Service Bulletin No. 1089

COACH MODEL	: T2140, T2145, and S2145
BULLETIN TYPE	: Field Change Program: NHTSA campaign number 01V-176
MANUAL & SECTION	: Maintenance Manual: Chapter 11 - Body and accessories Spare Parts Manual: Section 753309 - Wiper
PARTS BOOK REVISION	: Yes
DATE	: October 31st, 2001
SUBJECT	: Windshield wiper linkage
TERMS & CONDITIONS	: Refer to the customer notification letter. Parts and labor allowance will be provided as per warranty information in this Bulletin.

Van Hool have determined that the windshield wiper actuating lever may become disengaged from the wiper motor shaft. If this occurs, the windshield wipers will cease functioning. The procedure in this Bulletin provides the necessary information to remedy this condition.

Figure 9: Wiper motor dust cap installation

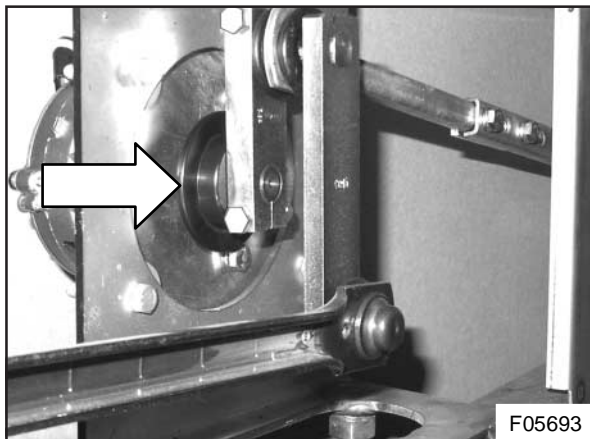
To further improve wiper motor protection, a motor shaft dust cap should be fitted.

Install the motor shaft dust cap VH 10757900 (see Figure 7) by simply pushing it on the shaft as shown in Figure 8. Proper dust cap installation is shown in Figure 9.

Figure 10: Clamp (1) and bell crank (2) with "BRB" mark.

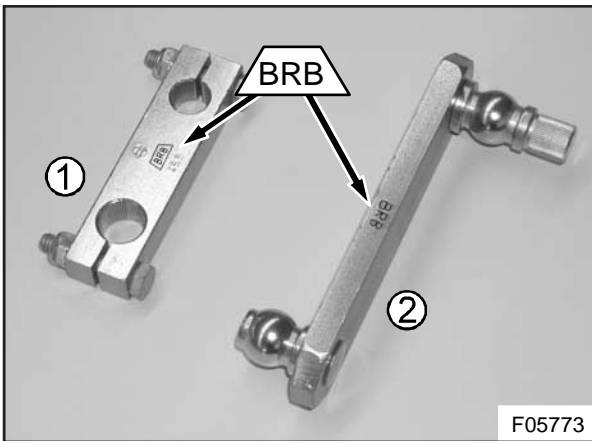
- Reassembly is the reverse of disassembly.
- The new bell crank and clamp have been marked “BRB” (see Figure 10).
- Lightly lubricate the bell crank knuckles before installing the tie bars.
- Mind the tie bar dust cap installation.
- Make sure the bell crank knuckle shaft does not protrude through the clamp. The shaft end should be *flush* with the clamp.

- Parts will be forwarded to customers free of charge.
- Old and new parts are directly interchangeable.
- Only new parts will be offered as service replacements for this application.
- New bell crank and clamp can be identified by a "BRB" mark.
- Always use genuine maintenance products and parts. Do not accept imitations.
